**RE: CRANBROOK SCHOOL REDEVELOPMENT SSD
REVIEW OF ENVIRONMENTAL IMPACT ASSESSMENT
TRAFFIC AND PARKING ASPECTS**

The Transport Planning Partnership (TPPP) has been engaged by Today Pty Ltd to undertake an independent review of the traffic and parking aspects of the proposed State Significant Development (SSD) for the redevelopment of the Cranbrook School at Bellevue Hill.

Figure 1 – Proximity of 23 Victoria Road to Proposed School Drop Off / Pick Up Exit

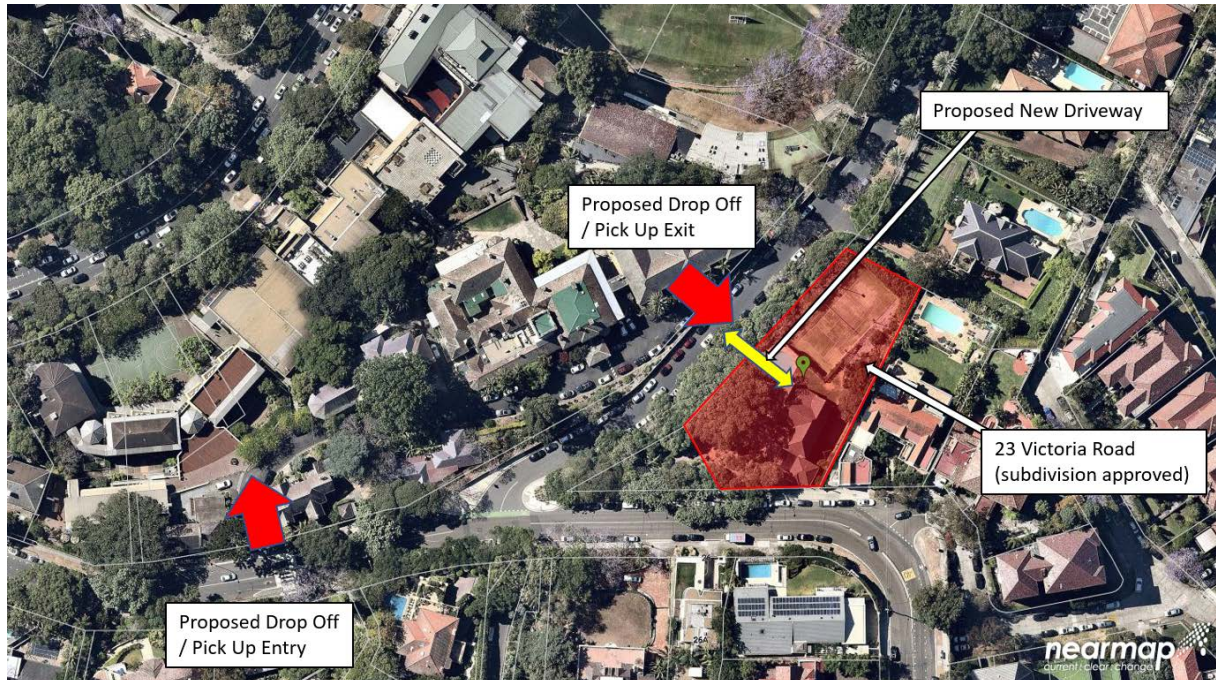
As shown in Figure 1, the site of 23 Victoria Road has road frontage to Rose Bay Avenue and Victoria Road and is sited opposite Cranbrook School. Specifically, 23 Victoria Avenue and its proposed New Driveway is located directly opposite the proposed new Cranbrook drop off / pick up access on Rose Bay Avenue as represented in the SSD application for the School redevelopment.

The immediate proximity of the proposed drop off / pick up vehicle access to the approved subdivision at 23 Victoria Road has obvious implications to the operation and safety of the existing and future vehicle access driveways to properties along Victoria Road.

As noted above in the background, a subdivision application has been made and approved which will create new property driveways on Rose Bay Avenue opposite the new drop off /

pick up zone exit driveway (see Figure 1 and Figure 2). The proposed mitigation measures for the drop off / pick up driveway, namely signage does not take into account the new driveways on the adjacent side of the road.

Figure 2 – Proposed On Site Drop Off – Pick Up Facility – Lack of Vehicle Storage

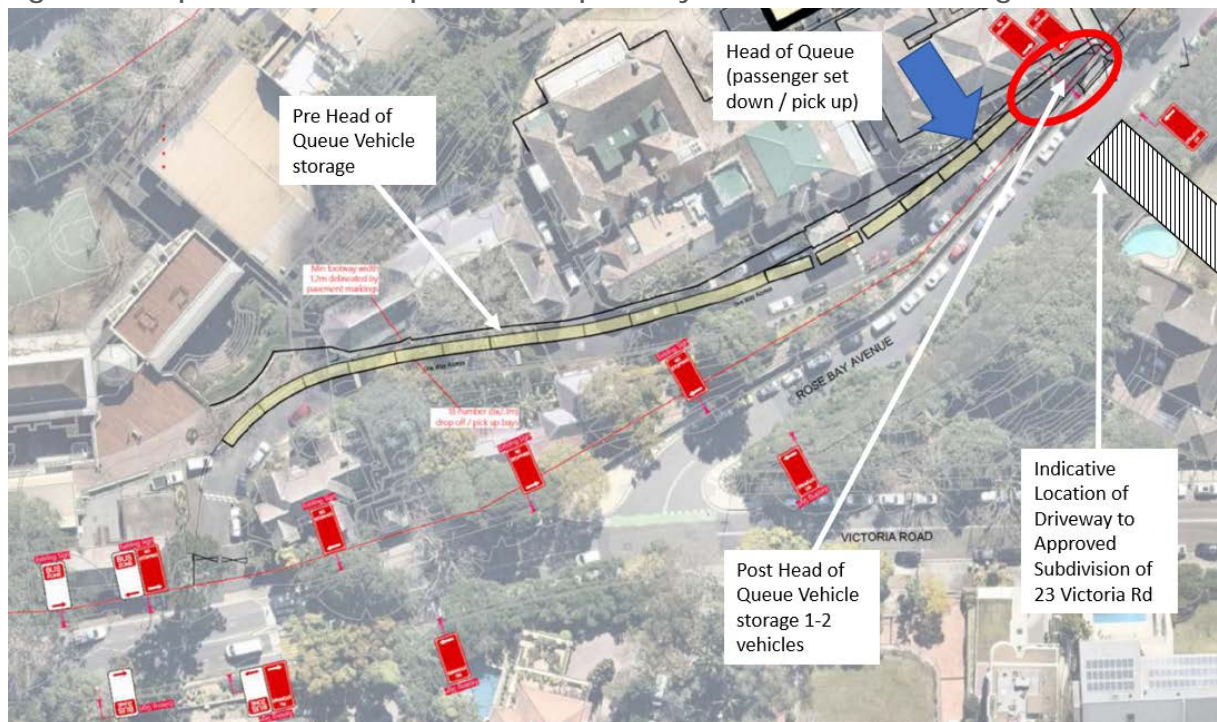
As shown in Figure 2, the storage area between the Rose Bay Avenue roadway and the head of queue for vehicles having dropped off or picked up a passenger is only 1-2 vehicles.

As such any vehicle queuing at the exit driveway will adversely impact the ability of vehicles to move through the drop off / pick up facility, thus exacerbating queues onto Victoria Road.

It is noted that no assessment or analysis of the potential vehicle queuing at the drop off / pick up exit to Rose Bay Avenue has been provided in the Traffic Report.

An analysis has been provided for the drop off – pick up entry access at Victoria Road but the analysis has assumed that any vehicle turning into the facility will be able to free flow along and clear the access driveway intersection. As noted above, it is TTPP's opinion that this assumption is unlikely to occur during peak periods and the analysis should be reconsidered.

The potential for queuing at the proposed drop off / pick exit at Rose Bay avenue will be significantly worsened if both left and right turn movements out of the driveway are permitted.

Furthermore the alignment of the internal road as it approaches the Rose Bay Avenue gate creates a very acute angle such that vehicles will not be near perpendicular with the footpath crossing and road as prescribed by AS2890.1 thus making drivers look around and over their shoulder to see approaching pedestrians and vehicles in an undesirable manner.

Sight lines to pedestrians at this driveway need to be considered very carefully with improvements to pedestrian sight lines and / or manually controlled with traffic controllers.

Thus for operational and safety reasons, if the proposed drop off /pick up is approved then it recommended that vehicle movements out of the exit be restricted to **LEFT TURN OUT ONLY**.

Figure 3 – Alternate Solution for On Site Drop Off – Pick Up Facility

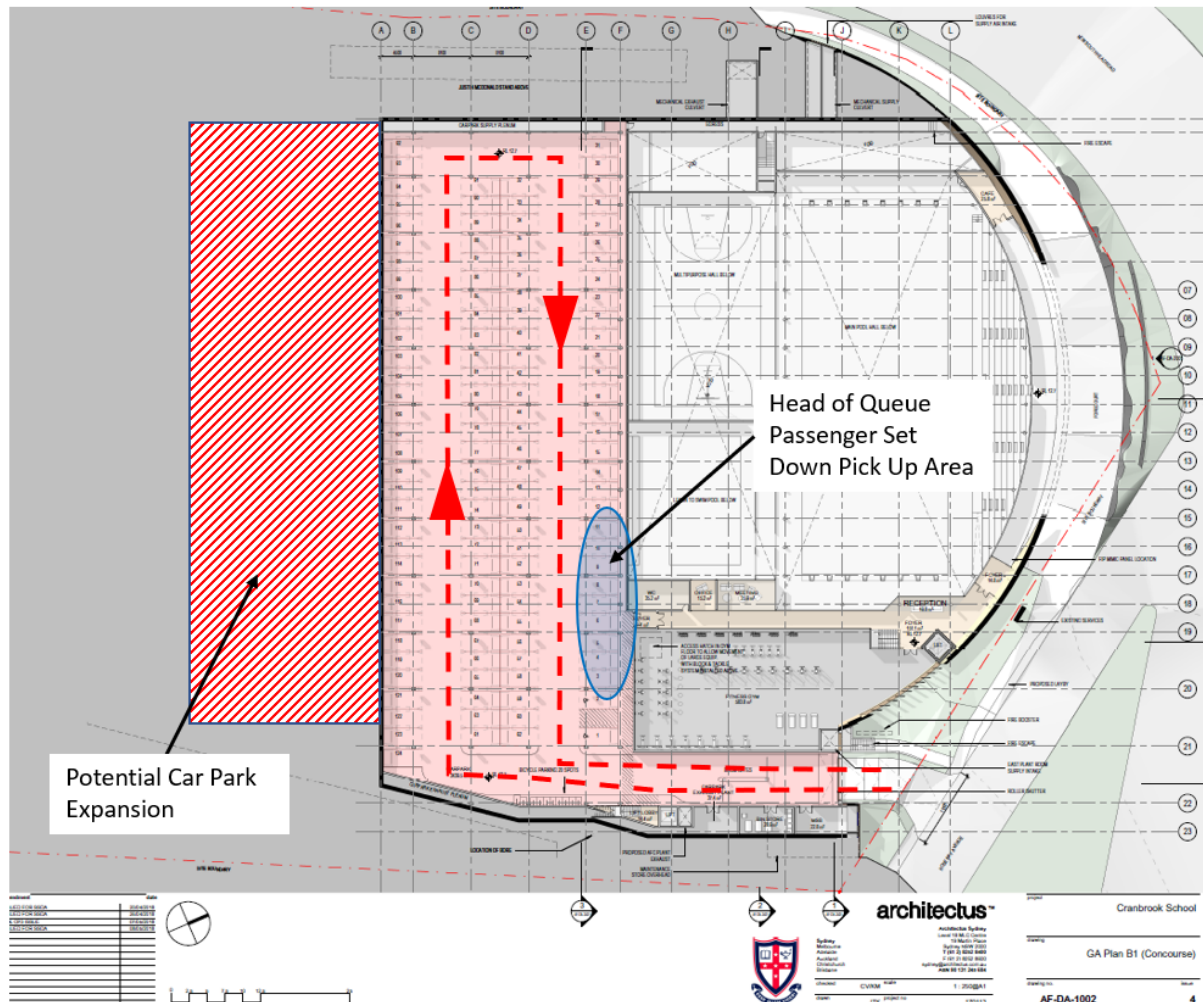
If operational capacity at the access / Rose Bay Avenue intersection can be satisfactorily addressed, it is suggested that the proposed new car park under the oval be utilised during drop off and pick up periods for the purpose of picking up and setting down passengers by utilising the internal vehicle circulation aisle for vehicle storage and on site queuing.

The alternative arrangement could potentially be provided as shown in Figure 3.

The alternate arrangement would potentially increase the on site storage area from 110 metres (as proposed in the SSD) to approximately 200 metres.

As shown in Figure 3, it is suggested that the extension of the car park to the east be considered to assist with the combined operation of the drop off / pick up facility and the aquatic centre uses.
